Subject: Response To Request For Additional Information – Radiological Consequence  
Analysis For Control Room Operators (TAC No. MA 3465)

Oyster Creek Generating Station (Oyster Creek)  
Facility Operating License No. DPR-16  
NRC Docket No. 50-219

**Response to Request for Additional Information - Radiological  
Consequences Analysis for Control Room Operators**

Figure 1 Site Plot Plan showing principal release points

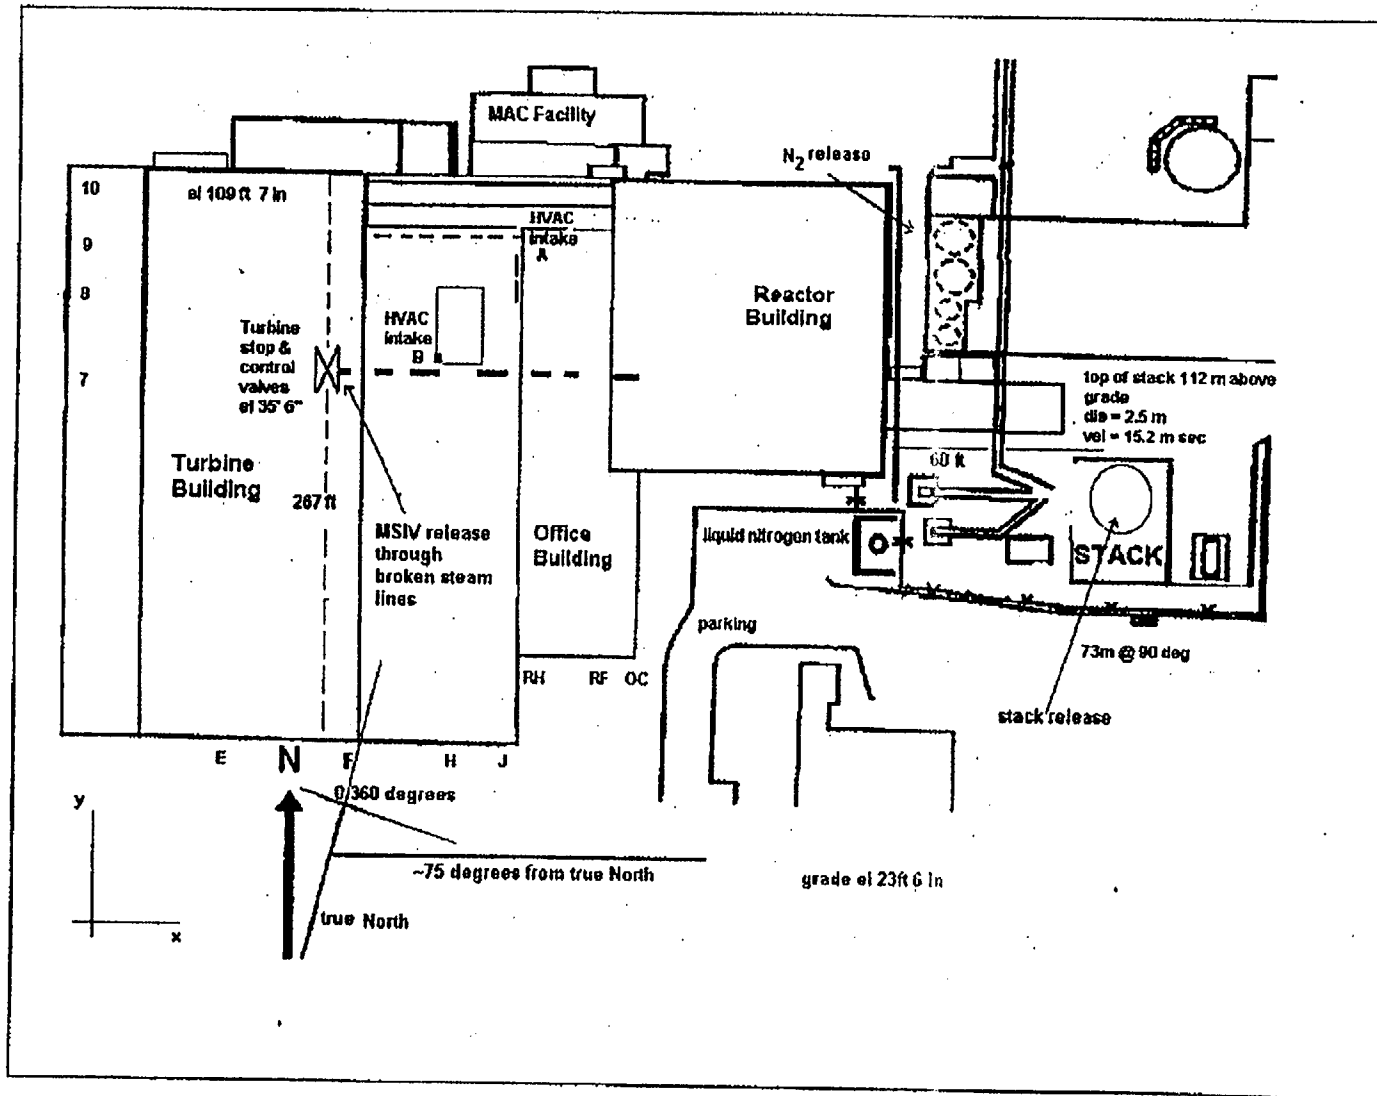
Where is the yard release location cited in the January 12, 2001, submittal and what methodology, inputs, and assumptions were used to calculate the control room intake relative concentration (X/Q) values? Why does selection of the assumed location and associated inputs and assumptions ensure that the resultant X/Q values are adequately conservative? Provide or reference plant drawings in the Safety Analysis Report or elsewhere that show the relationship between potential release locations from plant systems to the environment and from the environment to the control room intake with respect to distances, structural dimensions, and directions from true north.

The yard release is from a postulated rupture of the N<sub>2</sub> supply system, which provides purge for the drywell and torus. This release is not included in the current licensing basis for Oyster Creek but has been assumed in this analysis for additional conservatism. This line penetrates the reactor building on the Northeast corner of the reactor building. The distance from the N<sub>2</sub> line penetration at the reactor building Northeast corner to the "A" HVAC control room air intake is 45.1m. The "A" HVAC control room air intake is the closest of the two intakes to the N<sub>2</sub> line yard release point. For conservatism, the calculated X/Q for the N<sub>2</sub> line yard release to the "A" intake is also applied to the "B" intake. The release point for either of the two N<sub>2</sub> system reactor building bypass pathways located on the east side of the reactor building is assumed to lie in a direction 75 degrees from the control room air intake. The exact location of the potential release cannot be determined since the N<sub>2</sub> line runs along the wall of the reactor building. However, the short distance from any potential release point is in a direction normal to the east wall that runs 345 to 165 degrees, or approximately North-South. The normal to the east wall would, therefore, be at 255 degrees. The attached Figure 1, excerpted from supporting Calculation No. C-1302-826-E540-017, shows the relationship between the N<sub>2</sub> line yard release location to the environment and from the environment to the control room intake with respect to distances, structural dimensions, and directions from true north. This calculation is provided in AmerGen letter to the NRC dated September 24, 2001 (2130-01-20177).

As stated above, the exact location of the potential release cannot be determined since the N<sub>2</sub> line runs along the wall of the RB. However, the shortest distance from any potential release point is in a direction normal to the east wall that runs 345 to 165 degrees, or approximately North-South. The normal to the east wall would, therefore, be at 255 degrees. Therefore, adequate conservatism exists.
